Re: *In the Matter of Walleye Wind, LLC for a Certificate of Need for the Walleye Wind Project and Associated Facilities in Rock County, MPUC Docket No. IP7026/CN-20-269*

Walleye Wind, LLC – Certificate of Need –Application Amendment

Figure 1. Project Layout

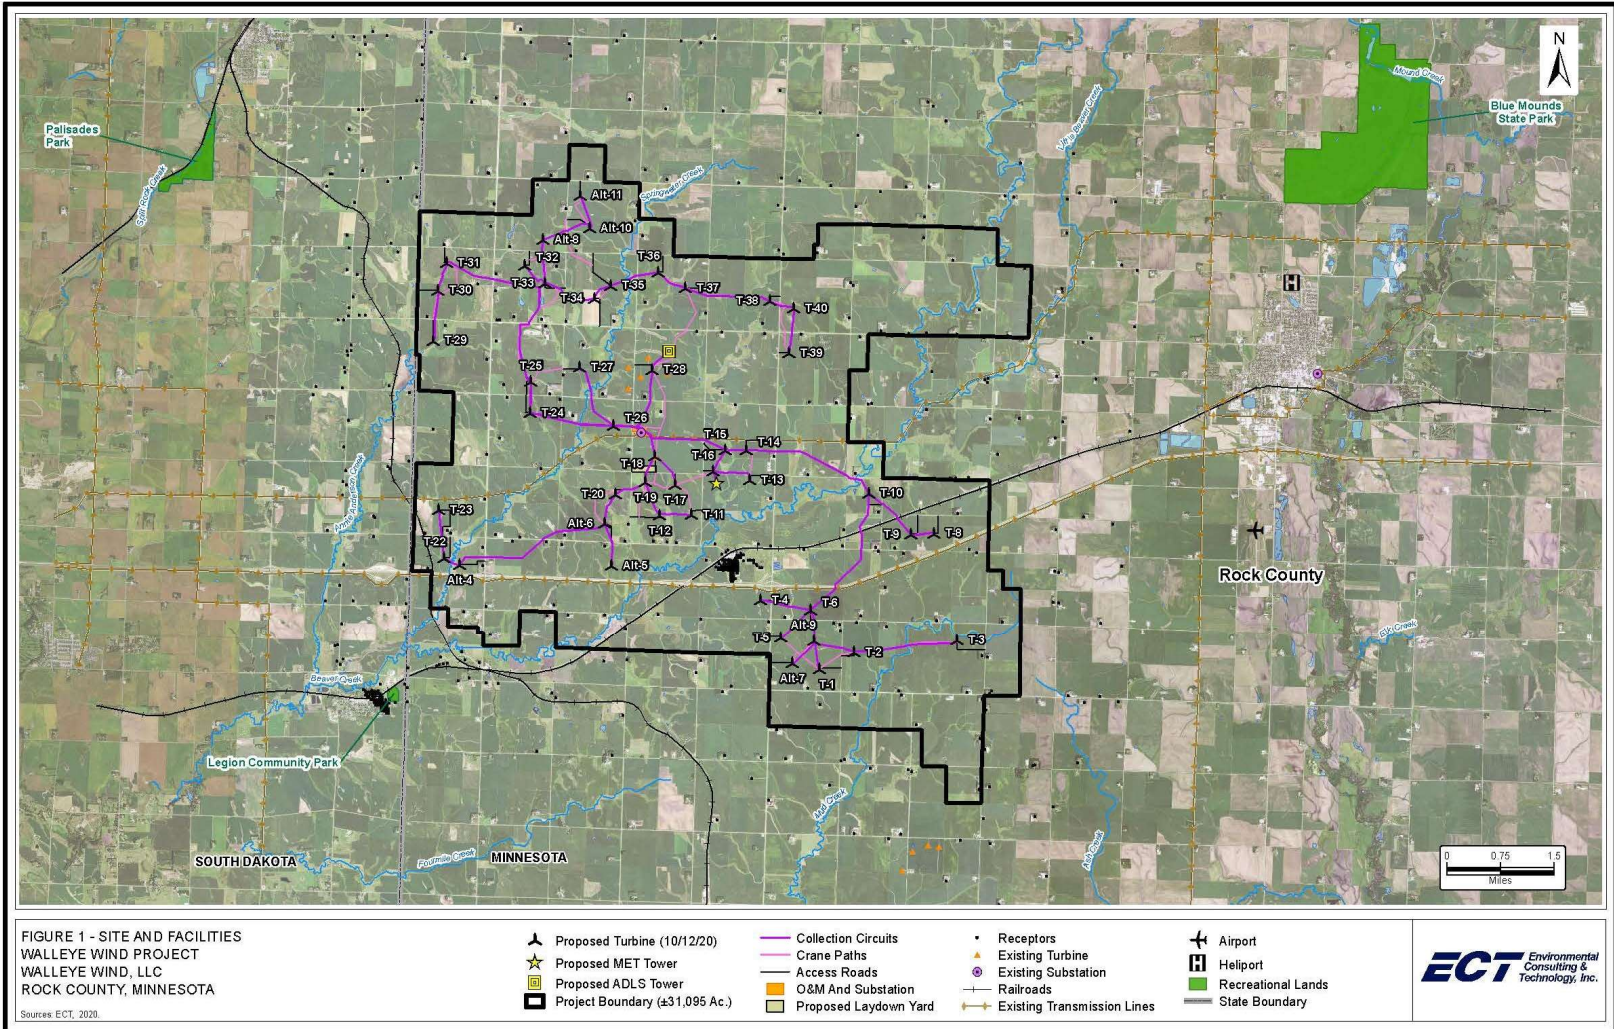
A map comparing the Initial Application wind turbine array and this Application Amendment wind turbine array is provided in **Attachment A**. Access roads, collection routes, and crane walks were adjusted to accommodate the revised turbine array, which can be seen in **Figure 1**, below. Maps have been updated to reflect the Application Amendment modifications and are herein provided in **Attachment B**. Sections of the Initial Application or appendices that did not change are not summarized herein as the Initial Application

The Initial Application stated that four turbine models would be used for the Project, including: 2.82 MW, 114-meter hub height turbine; the 2.82 MW, 89-meter hub height turbine; and the safe harbor 2.32 MW, 80-meter hub height turbine; or the safe harbor 2.5 MW, 90-meter hub height turbine. The current project layout removed the option of using the safe harbor 2.5 MW turbines. A map showing the updated Project is provided below in **Figure 1**.
